Refer to: HSA-10/WZ-145

This is in response to your letter of December 3, 2002, requesting Federal Highway Administration (FHWA) acceptance of your company's Type I and II barricades, Vertical Panel, and Universal A-Barriers as crashworthy traffic control devices for use in work zones on the National Highway System (NHS). Accompanying your letter was product literature illustrating the various devices. You requested that we find these devices acceptable for use on the NHS under the provisions of National Cooperative Highway Research Program (NCHRP) Report 350 "Recommended Procedures for the Safety Performance Evaluation of Highway Features" without additional crash testing.

PMG Sentinel Type I and Type II Foldable "A"-Frame Traffic Control Devices

PMG Sentinel Type I Vertical Panel Foldable “A”-Frame Traffic Control Devices

Sentinel™

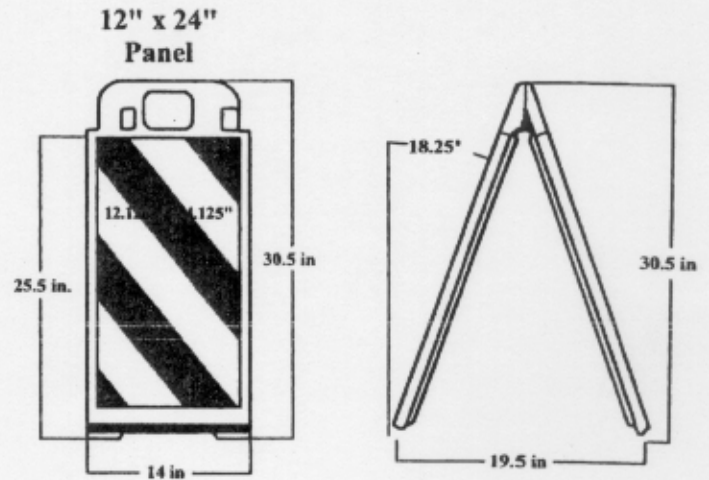
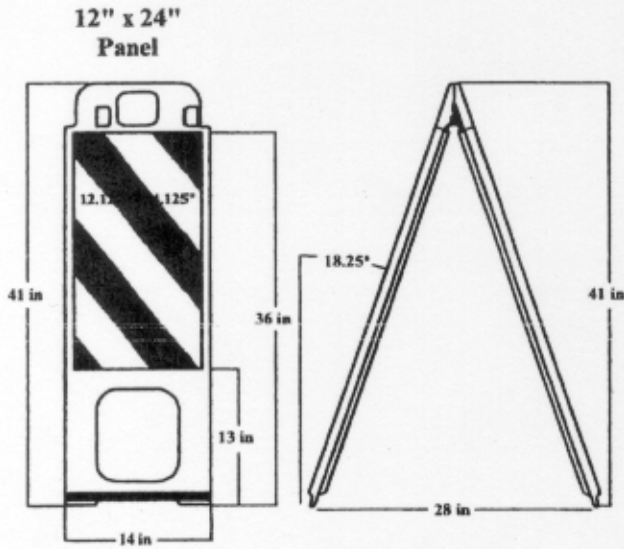
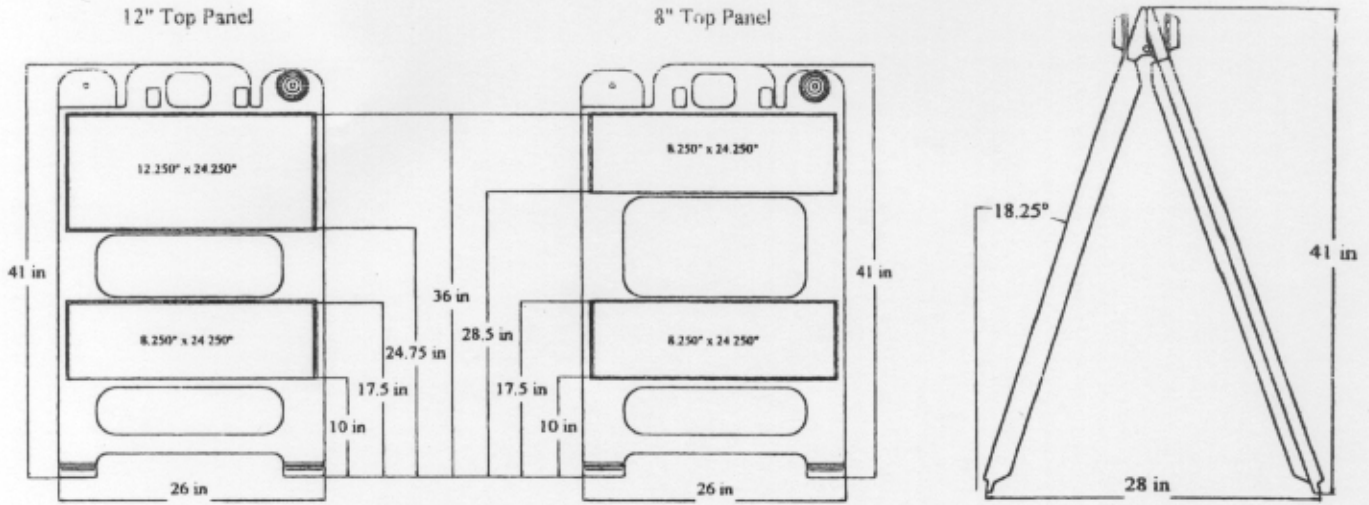
The PMG Limited high-density polyethylene plastic vertical panels and Type I & II barricades are similar in size, weight, and materials to other crashworthy vertical panels and barricades. They can be expected to perform as well as the generic steel leg barricades found acceptable in FHWA Acceptance Letter WZ-85 dated November 15, 2001. Therefore, the devices described in the various requests above and detailed in the enclosed drawings are acceptable for use on the NHS under the range of conditions that the generic barricades were tested, when proposed by a State. Note that this acceptance is for the barricades and vertical panels, plus reflective sheeting (and properly located ballast, if needed), only. If these are to be used with warning lights they should be crash tested with the type of light(s) they will be used with.

The results of the testing met the FHWA requirements and, therefore, the devices described in the various requests above and detailed in the enclosed drawings are acceptable for use on the NHS under the range of conditions tested, when proposed by a State.
